Authorized Field Change

AFC 20904

Subject: Inter-Axle Driveline

Model: International® MV™ Series

Figure 1. Replace Axle Seats

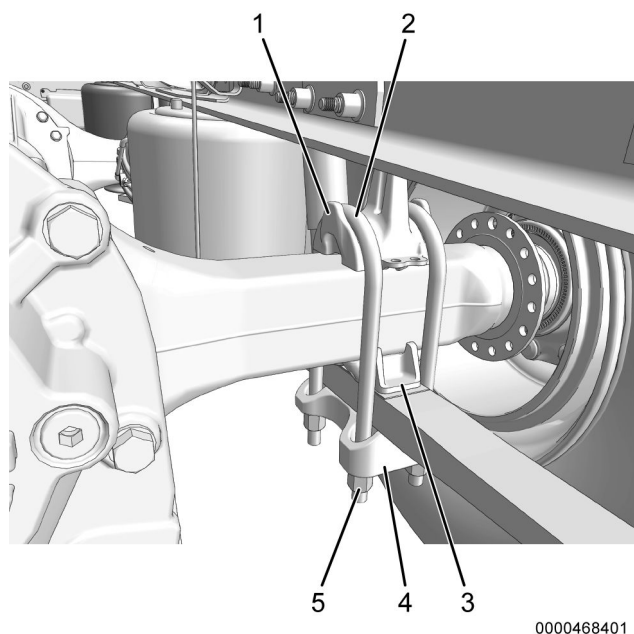
Certain International® MV™ Series trucks built with feature codes 14GVJ, 14GVX, or 14GVY (Axle rear tandem, Meritor MT 40 series) and with 14UNU (Suspension, rear air tandem 6X4 IROS) may have less than optimal driveline operating angles and this procedure is intended to improve inter-axle differential reliability.

NOTE: Follow appropriate axle seat orientation. For axle seat orientation, arrow should be pointing forward. Rear-rear axle plate should have thicker portion of wedge mounted forward.

NOTE: Forward-Rear axle seat P/N is 3601572C3 and Rear-Rear axle seat P/N is 3601585C3.

NOTE: Replace axle seats and plates on one side of each axle at a time. Forward-Rear Plate P/N is 3541720C3. Rear-Rear Plate P/N is 3541724C4.

5. Starting at the right forward rear axle, remove U-bolt nuts (Figure 1, Item 5) from U-bolts (Figure 1, Item 2). Remove U-bolts and lower axle seat (Figure 1, Item 4). Discard U-bolts, nuts, washers, and seat.
6. Using a suitable jack, raise axle from plate (Figure 1, Item 3). Remove and discard plate.
7. Install correct new plate (Figure 1, Item 3) and lower axle back into position.
8. Install new U-bolts (Figure 1, Item 5), correct lower axle seat, washers, and nuts.

Figure 2. Correct Torque Sequence

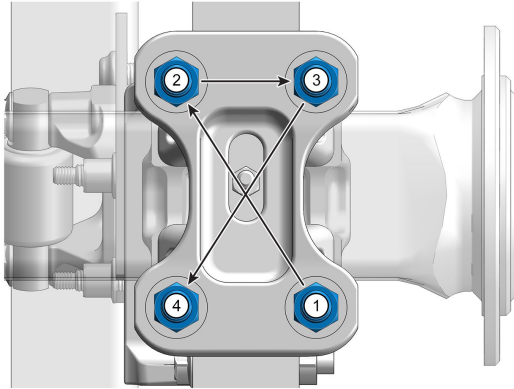
NOTE: When tightening and retightening U-bolt nuts, follow correct torque sequence as shown in Figure 2.

9. Using a torque wrench, tighten all U-bolt nuts to 15 lb-ft (20.3 N•m). Continue to retighten all U-bolts in the following order:
 - a. Retighten all U-bolt nuts to 100 lb-ft (136 N•m).
 - b. Retighten all U-bolt nuts to 200 lb-ft (271 N•m).
 - c. Retighten all U-bolt nuts to 300 lb-ft (407 N•m).
 - d. Retighten all U-bolt nuts to 400 lb-ft (542 N•m).
 10. Repeat Steps 5 through 9 for three remaining axle seats and plates.
 11. On forward rear axle only, drain and fill forward rear axle lubricant.
 12. Measure vehicle ride height. Refer to appropriate section of International® MV™ Service Manual for detailed instructions.
- NOTE: Ride height measurement is found in the description for rear axle suspension under the components tab on International® Service Portal™ organized by VIN in the Labor table.**
13. If necessary, adjust ride height to specification.
 14. Remove wheel chocks.
